<p style="text-align: center;"><b>Advisory Action</b> <b>Before the Filing of an Appeal Brief</b></p>	<b>Application No.</b> 10/666,865	<b>Applicant(s)</b> KIM, MIN-SU	
	<b>Examiner</b> Jennifer M. Dolan	<b>Art Unit</b> 2813

THE REPLY FILED 02 December 2005 FAILS TO PLACE THIS APPLICATION IN CONDITION FOR ALLOWANCE.

Continuation of 11. does NOT place the application in condition for allowance because:

Correspondence between figure 7B and figure 8B features

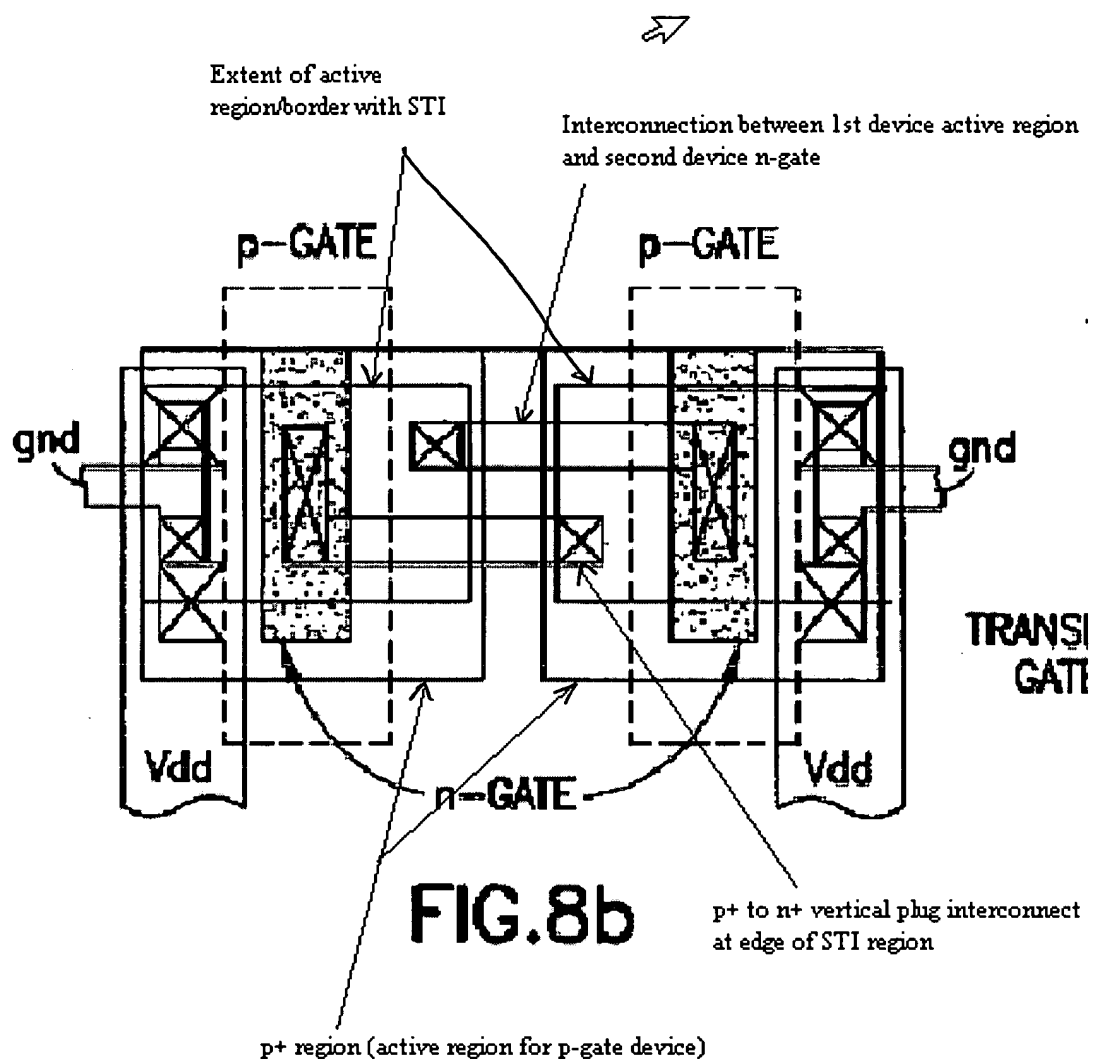
The Applicant further argues that the SOI layers are located entirely in the active region, and no part of the SOI is disposed in the device isolation area. Hence, "it is incorrect to interpret Assaderaghi's shallow trench isolation regions as being included in, or part of, the SOI layer." This is not persuasive, because Assaderaghi clearly shows the STI regions disposed within the exact same layer as the SOI regions. Hence, it would be considered normal and proper to state that the STI regions are formed in the SOI layer. Assaderaghi additionally indicates that the SOI substrate is provided, and then STI structures are provided in that SOI layer, preferably with the bottom of the STI extending to the top of the buried oxide layer (see column 5, lines 43-62). Furthermore, it is not particularly relevant whether the STI structures of Assaderaghi are considered to be inside the SOI layer, since Assaderaghi, when combined with Chen, provides a structure in which a portion of the SOI layer remains underneath the isolation structure.

The Applicant even further argues that the "left-most" n gate of fig. 8b is not disposed over the oxide isolation portion, and that it is not apparent in figure 8b where the active region is located. This is not persuasive, because the term "over" only requires that the feature be at a level higher than the active area and STI, rather than requiring any sort of overlap between the features. Furthermore, figure 7b directly shows and overlap between the n-gate and the active region. Similarly, since figures 7b and 8b show side and top views of the same area, it is apparent that the STI region includes an area directly under part of the n-gate (see attached figures).
